**GE Hitachi Nuclear Energy**

MFN 09-556

**Subject: Response to Portion of NRC RAI Letter No. 350 Related to ESBWR Design Certification Application – DCD Tier 2 Section 4.4 – Thermal and Hydraulic Design; RAI Number 4.4-23 S03**

**RAI Number 4.4-23 S03**

Figure 2.6.2-1. Fuel and Auxiliary Pools Cooling Cleanup System

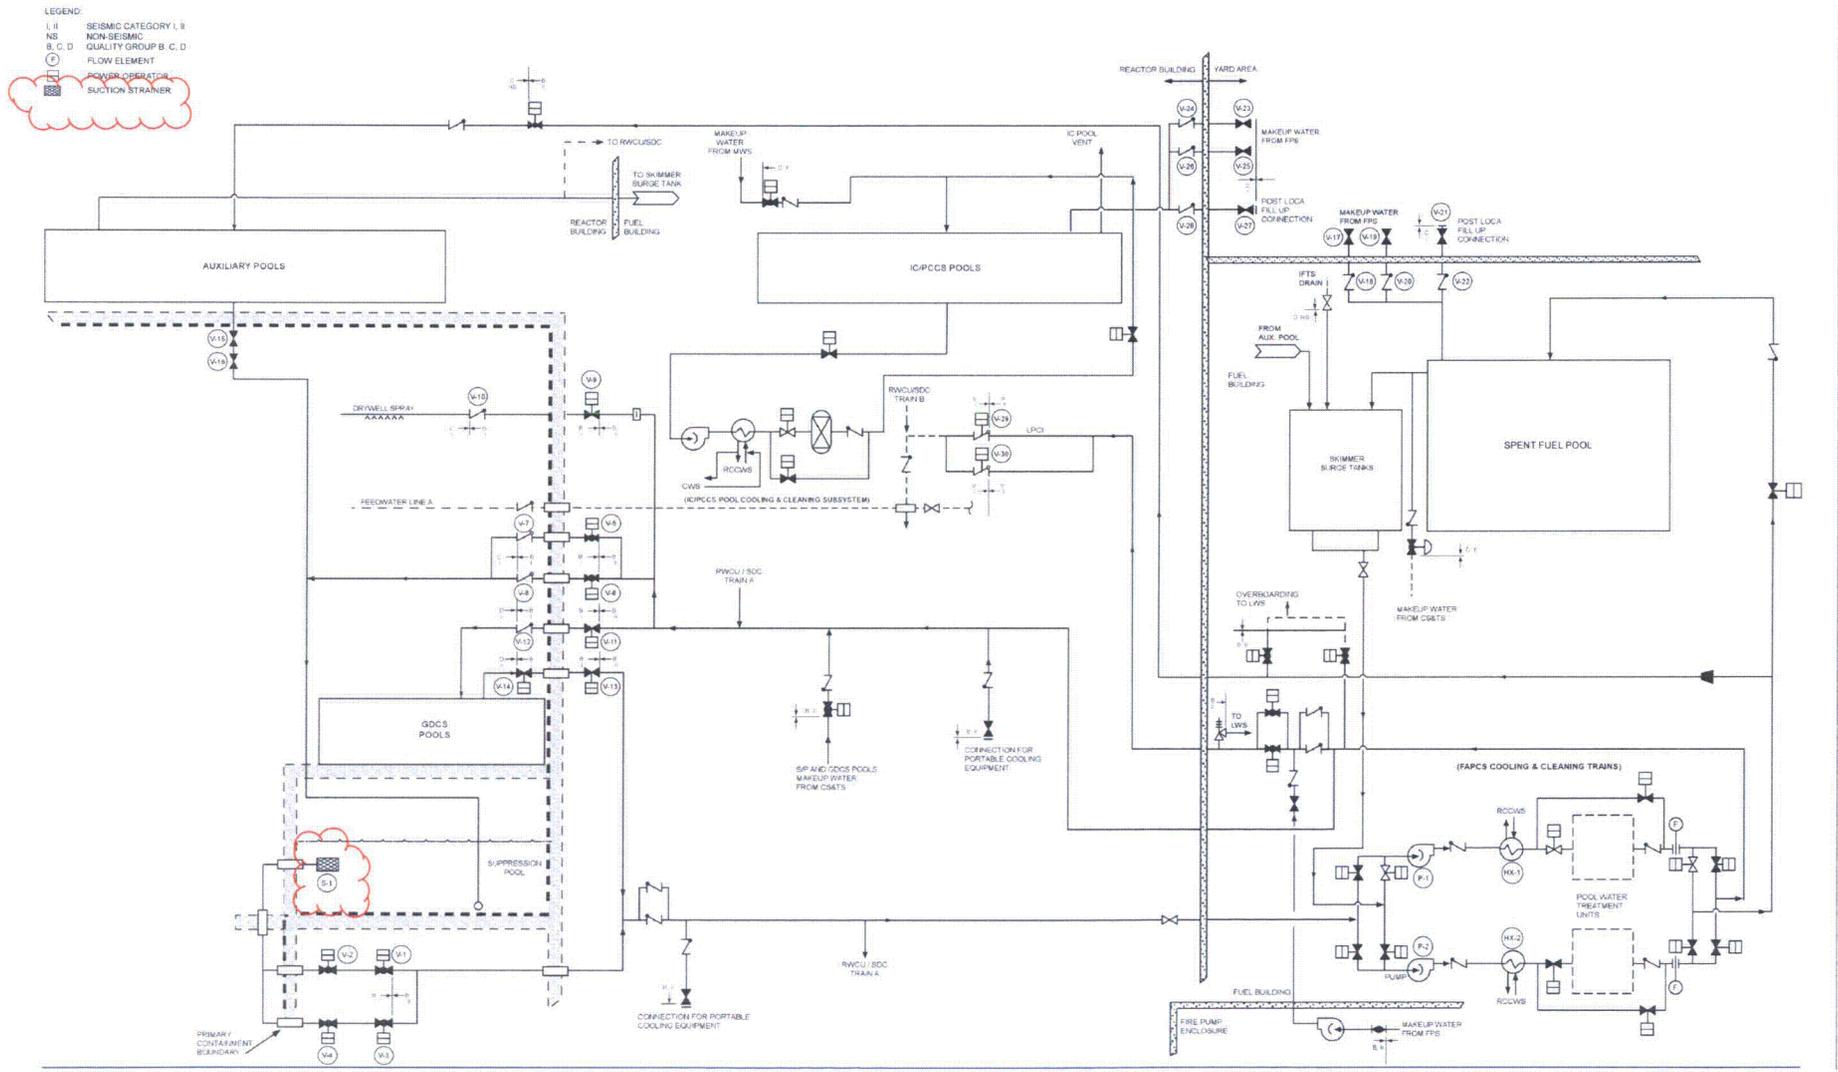
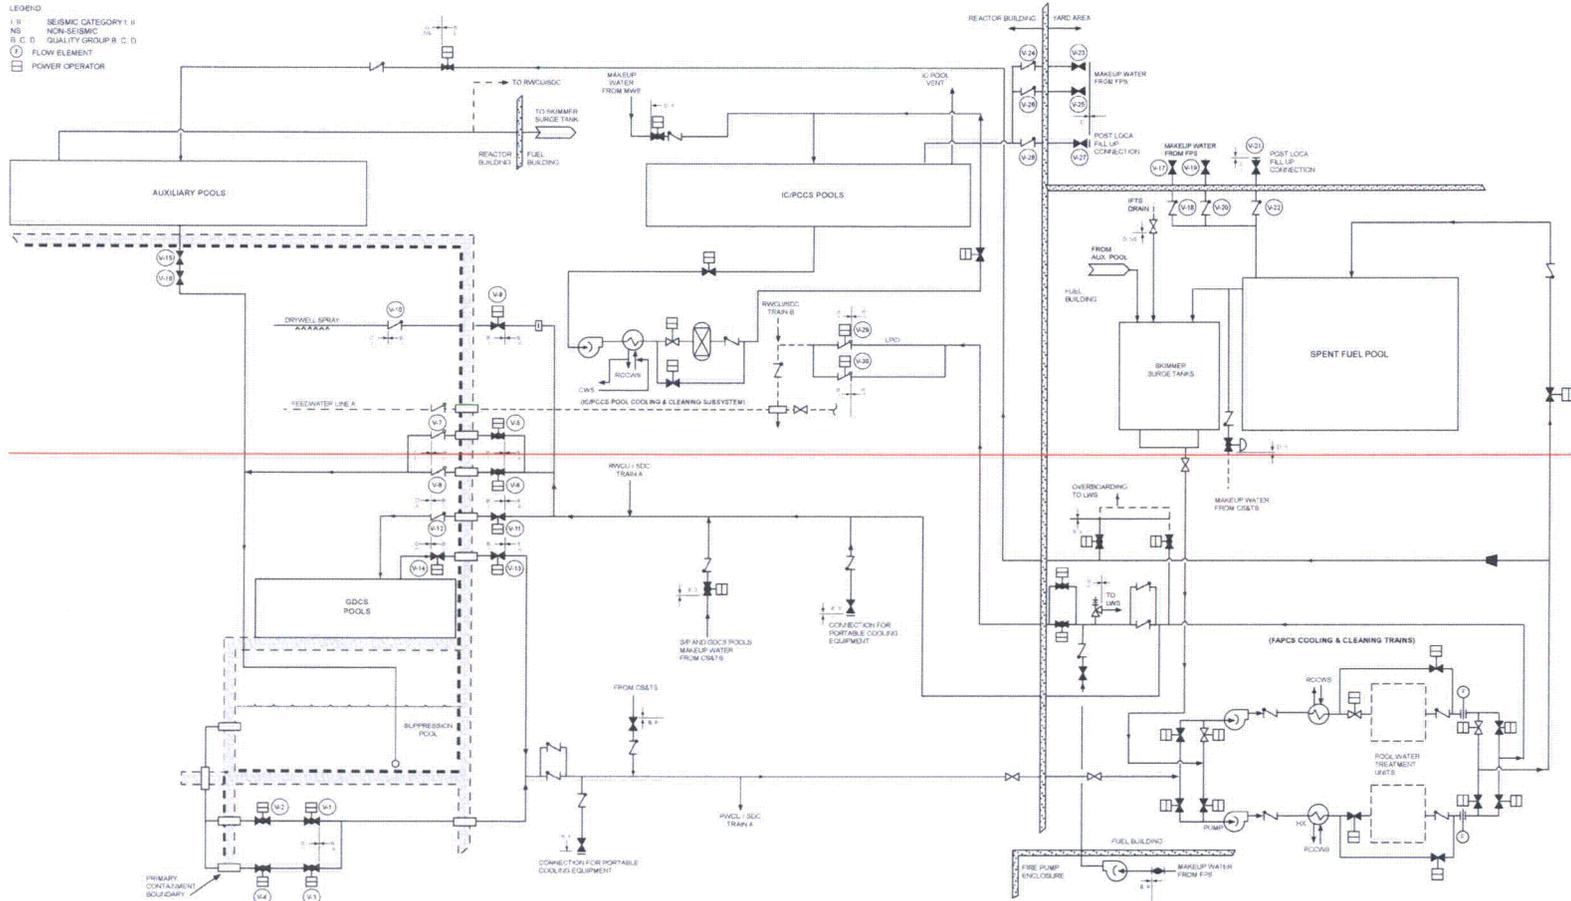
The FAPCS suppression pool suction strainer is a Seismic Category I component (DCD Tier 2, Table 3.2-1). DCD Tier 2 Subsection 9.1.3.2 will be revised to add the perforated plate hole size and DCD Tier 1 Table 2.6.2-1, Table 2.6.2-2, and Figure 2.6.2-1 will be revised to add the suction strainer.

DCD Tier 1 Table 2.6.2-1, Table 2.6.2-2, and Figure 2.6.2-1 and Tier 2 Subsection 9.1.3.2 will be revised as noted in the attached markups.
